G3NO-2008-00016

SUBJECT: Responses to NRC Requests for Additional Information, Letter No. 15
(GG3 COLA)

RESPONSE TO NRC RAI LETTER NO. 15

Nuclear Project Structure – RB3N & GG3N

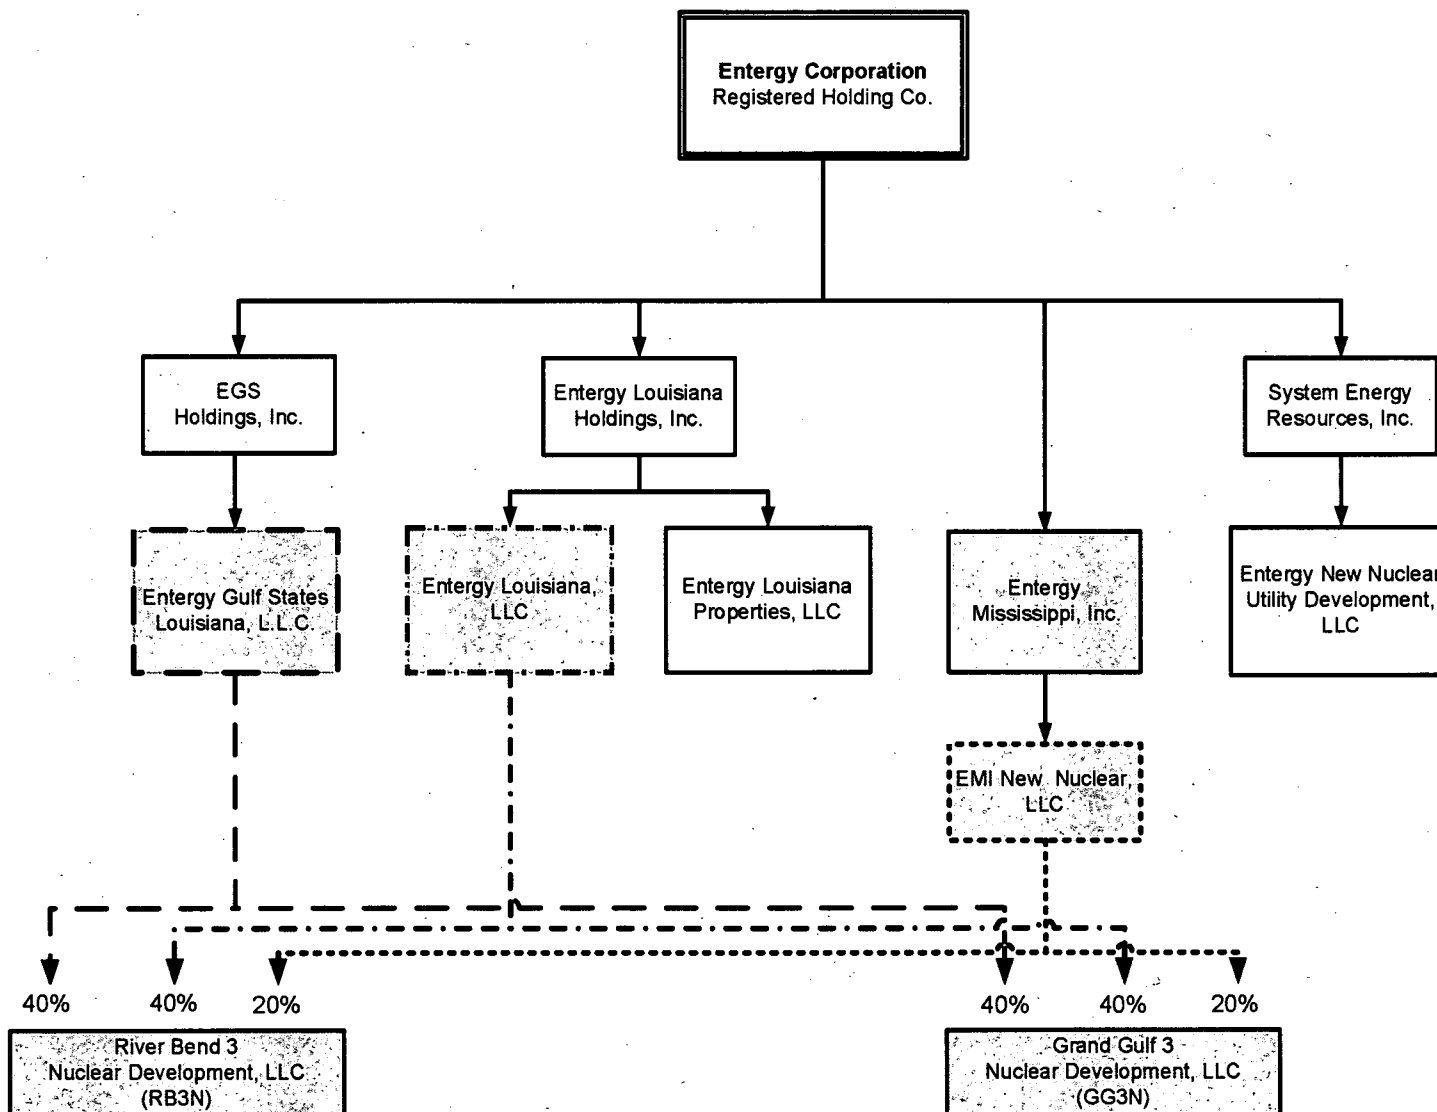
- a) In Section 1.1 – Applicants – Corporate Information, the application states that Entergy Mississippi, Inc. (EMI); Entergy Louisiana, LLC (ELL); and Entergy Gulf States Louisiana, L.L.C. (EGSL) will own GGNS Unit 3. However, the application also states that “The ownership shares among these three companies have not yet been determined.” The staff requests that the applicants state when the percentage of ownership of GGNS Unit 3 between EMI, ELL, and EGSL will be finalized.
- b) In Section 1.1 – Applicants – Corporate Information, please provide an abbreviated chart showing the relationship of EMI, ELL, and EGSL to the parent company, Entergy Corporation.

- b) Currently, the project to be licensed under the GGNS Unit 3 COL application is expected to be owned entirely by GG3N, which in turn will be owned entirely (directly or indirectly) by Entergy's regulated utility operating companies EMI, ELL, and EGSL.

The diagram below shows the relationship between Entergy Corporation and the regulated utility subsidiaries participating in the project.
